# SAFETY ALERT SA0004

**EFFECTIVE DATE:** This Safety Alert is effective December 08, 2006  
**SUBJECT:** Aft Control Stick  
**MODELS AFFECTED:** CC11-100 S/N CC11-00002 thru CC11-00004.  
**COMPLIANCE TIME:** Prior to Next Flight  
**PURPOSE:** Aft Control Stick Replacement

**Figure 1– Aft Control Stick**

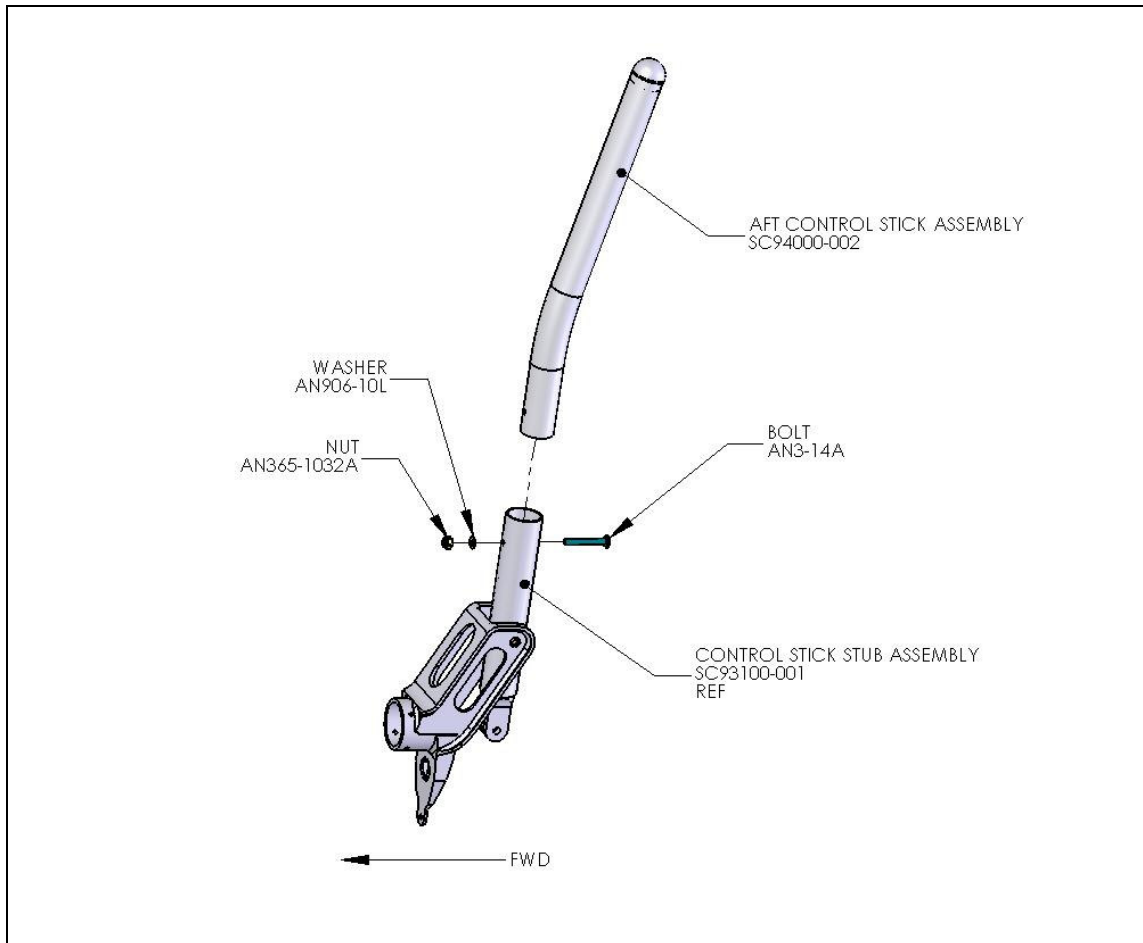
1. Remove bolt (AN3-14A), washer (AN960-10L), and lock nut (AN365-1032) from existing assembly.
2. Remove control stick assembly (SC94000-002) revision NC from control stick stub assembly (SC93100-001).
3. Discard control stick assembly (SC94000-002) revision NC (straight stick).
4. Place control stick assembly (SC94000-002) revision A (bent stick) into control stick stub assembly (SC93100-001) as shown in figure 1. Ensure bend is toward the aft end of the aircraft.
5. Replace bolt (AN3-14A), washer (AN960-10L), and lock nut (AN365-1032) as shown in figure 1.
